TO: Mercedes-Benz Dealer Principals, General Managers, Sales Managers, Service Managers, Parts Managers	FROM: Gregory Gunther, Department Manager, Vehicle Compliance and Analysis, Engineering Services
RE: <b>Service Campaign Launch Notification</b> <b>Check and Replace Vehicle Placard on B-Pillar</b> <b>MY20-21 GLE-Class, GLS-Class (167 platform)</b>	DATE: July 29, 2022

Campaign No. 2022070010, July 2022

SUBJECT: **Model GLE-Class and GLS-Class (167 platform)**  
**Model Year 2020-2021**

## **Check and Replace Vehicle Placard on B-Pillar**

Figure 1

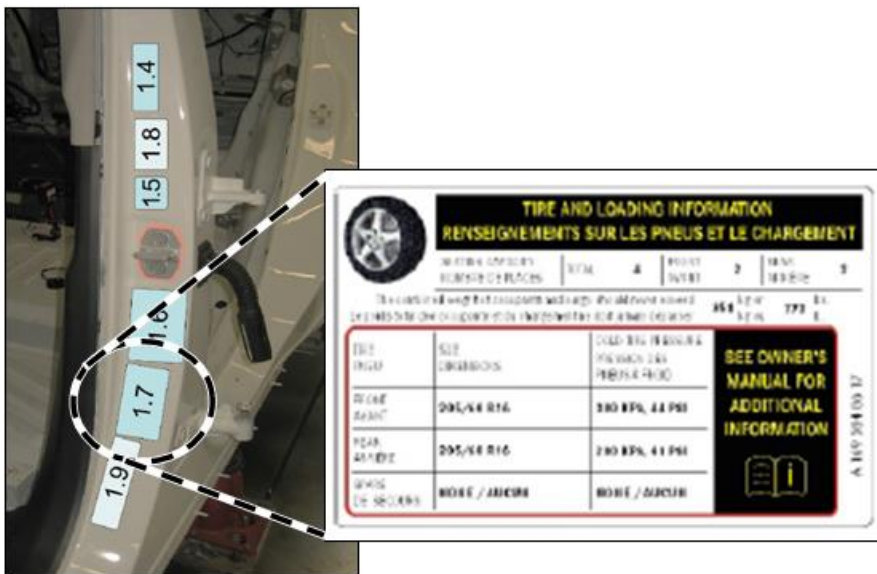
1. Check air pressure entry in VeDoc system in "Model plate" tab for 1st axle and 2nd axle (**figure 1**).

1. Open VEDOC-XSF ticket to have the VEDOC data corrected for "Model plate" tab for 1st axle and 2nd axle (**figure 1**).

**i** Air pressure data in VeDoc system must be taken from tire pressure label (**1.7 figure 2**).

**i** The data for the air pressure in the VeDoc system must be taken from the tire pressure label (**1.7 figure 2**).
